Revised Consolidated Decision

Hetherwood Residential Development

**Revised STAFF REPORT AND DECISION FOR
HETHERWOOD RESIDENTIAL DEVELOPMENT
(FILE #SPRV16-03)**

SITE PLAN REVIEW & CRITICAL AREA REVIEW

Preliminary Site Plan for Hetherwood (ne. Kate's Woods)

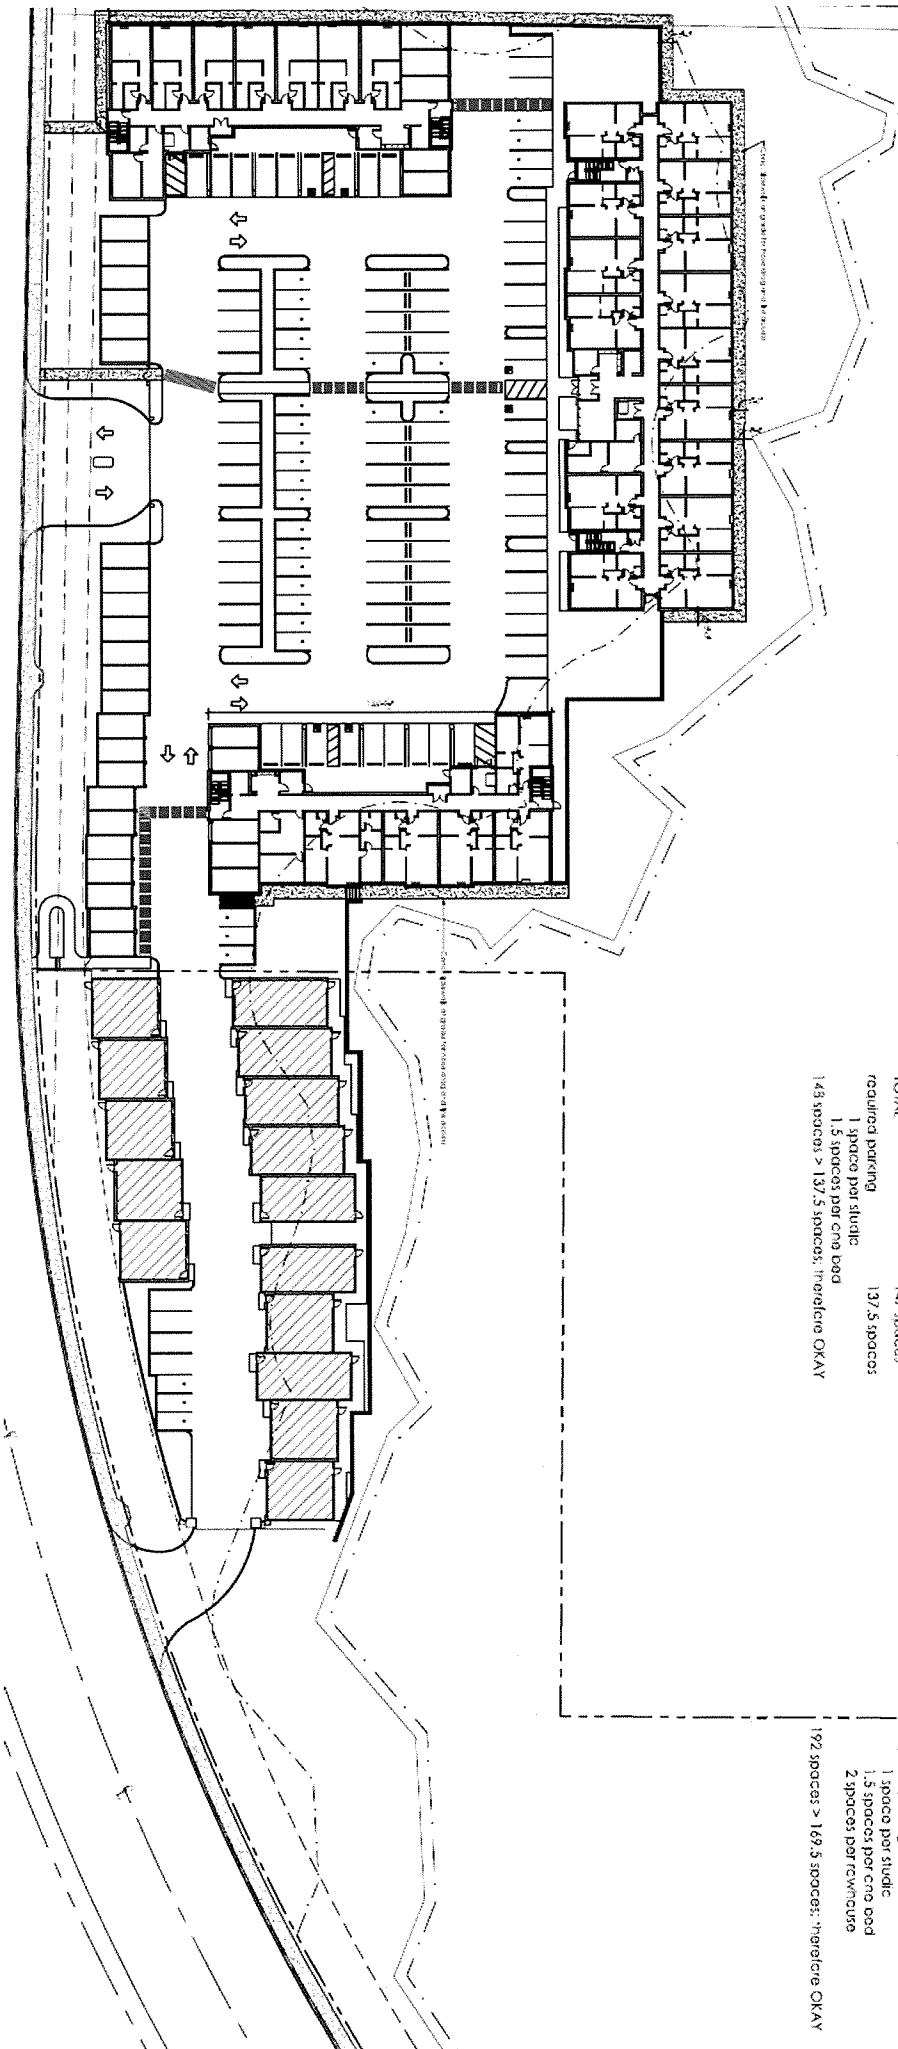
The westerly parcel (Phase 1) will have 134 units (127 studio apartments and 7 one-bedrooms) and will need to provide a minimum of **138 parking spaces**. The February 8th site plan drawing indicates that there will be 96 parking spaces within the open lot and 18 covered spaces for a total of **114 spaces**. The applicant has also proposed 33 spaces within the detached garage structures, and concluded that there would be a total of 147 parking spaces provided. However, the location of the garages appears to exceed the allowed distances to be counted toward parking for the multifamily use, as CMC§ 18.11.030 Location, requires that parking for multifamily dwellings be within 200-feet. The garages are located along the street frontage and the westerly garage (nearest corner), appears to be approximately 150 feet from the entrance of the West Apartments. The easterly garage appears to be over 220 feet from the East Apartment building. The North Apartment building is over 350-feet from either garage structure. It is possible that the West and East Apartments may have side entrances or exits that could shorten the distances to these garages, and open parking could be proposed in those locations instead. Without more details on the architectural layout, only the western garage with six (6) spaces meets the distance requirement. In summary, the property is short 18 parking spaces to meet the minimum parking requirements (Equation 138 – (114 +6) = 18). A shortage of parking on site, may produce a long term parking enforcement issue along NW Pacific Rim Blvd, where parking is not allowed. Per CMC§ 18.11.130 Standards, *"The city shall have the authority to request a parking study when deemed necessary."* Given that parking is not allowed on the frontage road for residents, guests or overflow, and as defined in CMC, the location of the detached garages will not function as parking spaces, a parking study may be required.

FINDINGS FOR PARKING: The off-street parking requirements for the row houses at the easterly parcel are in compliance with CMC. The westerly parcel has not met the off-street parking requirements for the apartment uses per CMC§ 18.11.030(B), CMC§ 18.17.040 and CMC§ 18.19.050(B)(3)(a)(iv).

35. The applicant shall revise the parking plan for Phase 1 to correct deficiencies as described in this report, and to comply with the off-street parking requirements per CMC§ 18.11.030(B), CMC§ 18.17.040 and CMC§ 18.19.050(B)(3)(a)(i and iv).

2 Adjacent residential development (typical style)

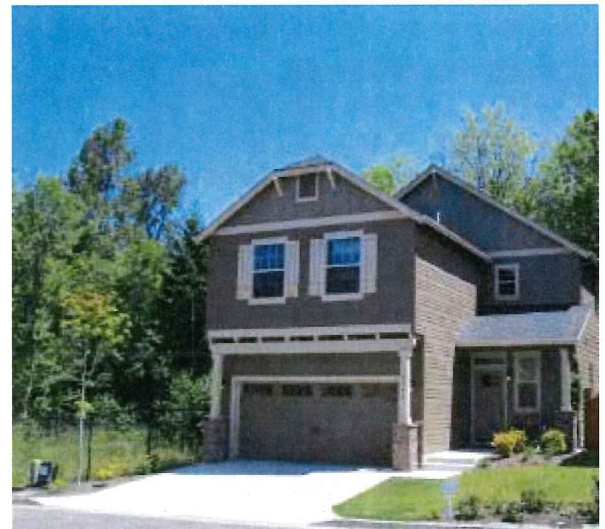
[Architectural Design] Design Review approval is required for all new developments within multifamily zones and within gateway overlays, per CMC§ 18.19.020 Scope. The design review standards within the city's Design Review Manual include mandatory elements in regard to site and building design. The guidelines and principles that must be included in the design are provided within CMC, and are more detailed within the city's Design Review Manual. The chapter's "Purpose" states that *"The design review process is intended to produce a meaningful integration of building, landscaping and the natural environment."* It is not clear from the submittal drawings (Figure 1) how the buildings will integrate the natural surrounding backdrop of the forested areas or the site topography that drops away from the street, or with the development to the west. To the north are forested areas and wetlands, which will likely be blocked from view with the current design proposed. To the west are residential structures, which include two story row houses and townhomes in the style as demonstrated with the inset photo (Figure 2).

Stacked housing must include the following design elements which are not evident in the current submittal:

- Buildings shall have their principal pedestrian entrance along a street, open space or midblock passage with the exceptions of visible entrances off a courtyard.
- Walls shall be articulated in order to avoid a blank look and to provide a sense of scale and shall provide a minimum solid to void ratio of 70%/30%.
- Stoops, porches and direct individual entries should be included-encouraged at ground-floor units.

FINDING FOR DESIGN REVIEW: A condition in regard to Design Review is included with this decision, and specific design requirements that must be addressed.
